New York State Department of Environmental Conservation

November 19, 1999

Re: Arch Chemicals (#828018a) - 100 McKee Road, Rochester (C)

**Subject: Arch Rochester Site Feasibility Study
Draft Letter Work Plan for Dual Phase Extraction Pilot Test**

**WELL CONSTRUCTION DETAILS
ARCH ROCHESTER
FEASIBILITY STUDY
ROCHESTER, NY**

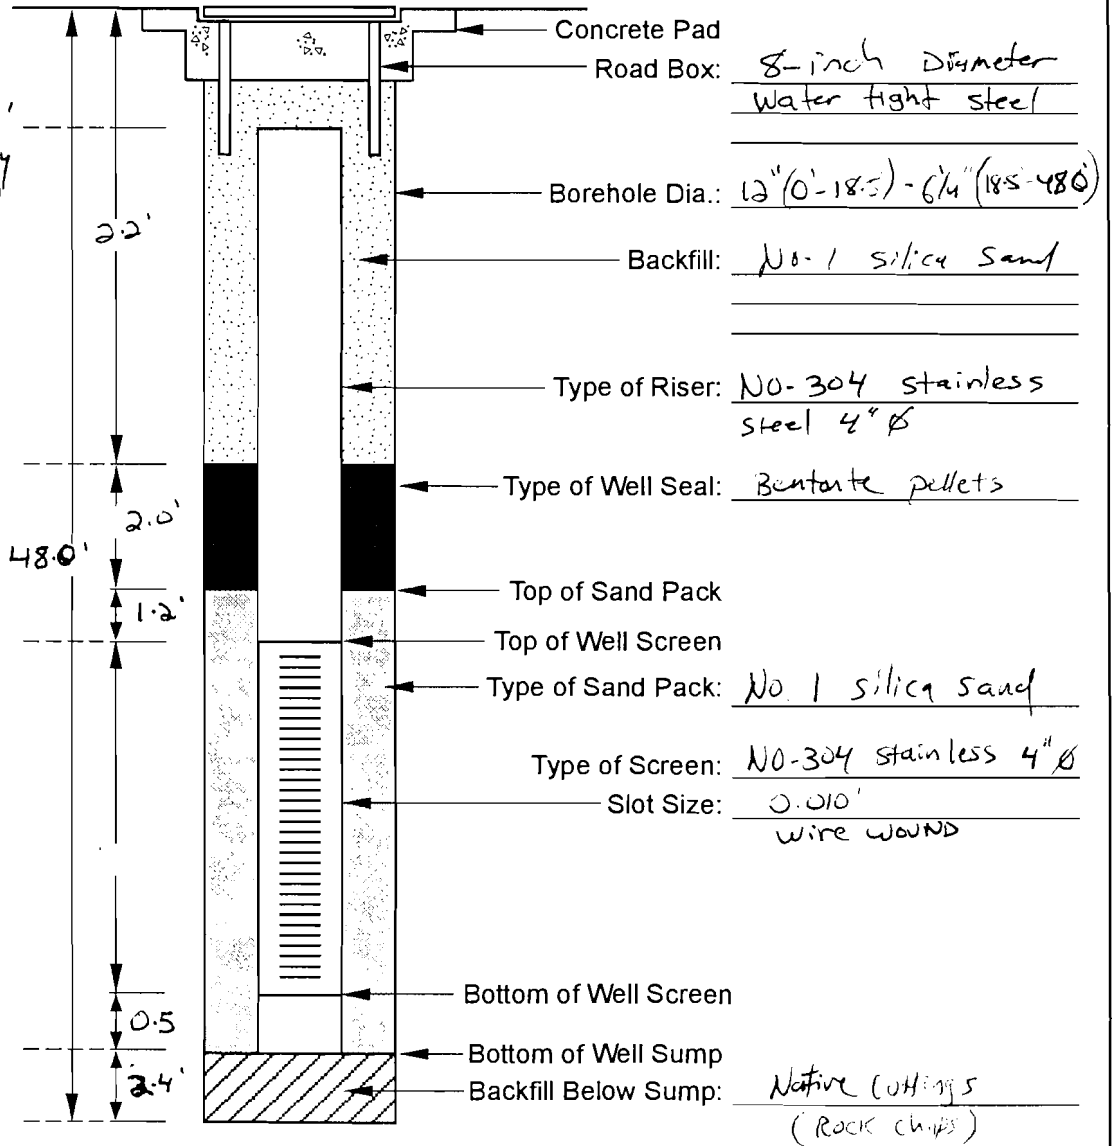
2. Is the log available for PW-10 and were any soil samples collected during drilling?
3. What type of groundwater pump will be used?
4. Other nearby wells should also be monitored for water levels and vacuum if possible (unsaturated screens) and measurements should be made frequently (certainly more often than "daily").
5. Vacuum of 3" to 5" Hg is quite low; consider ramping up step-wise (10" then 20") and measure differences in contaminant recovery and vacuum influence.
6. Is three days sufficient to properly evaluate the technology?
